# Access Compliance Report

## Public Rights-of-Way

Intersection ID: 19152	Main Street: E_INDEPENDENCE_BV	Cross Street: VILLAGE_LAKE_DR	Location:	N
ADA ID: 55CA76E25BE6	Ramp Type: PerpDiag	Initial Pass/Fail: Fail	Overall Compliance: No	Severity Score: 25
Codes/Mitigation Info/Possible Solution		Field Measurements/Component Compliance

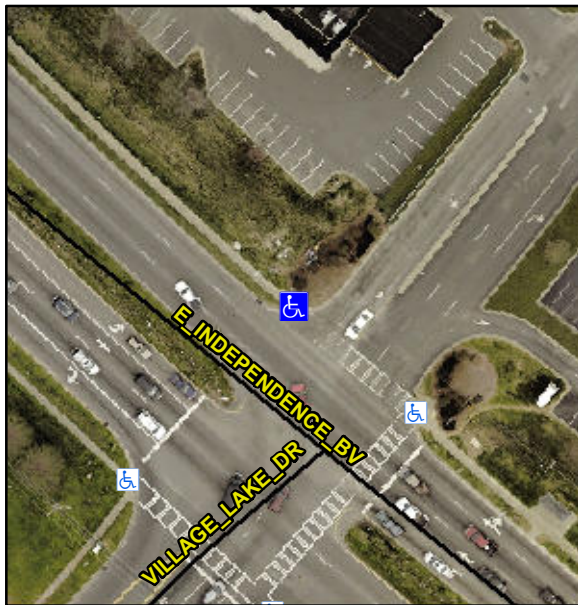
**Remove & Replace Curb Ramp With Two New Directional Ramps or Equivalent.**

**Not Found, R304.5.3**
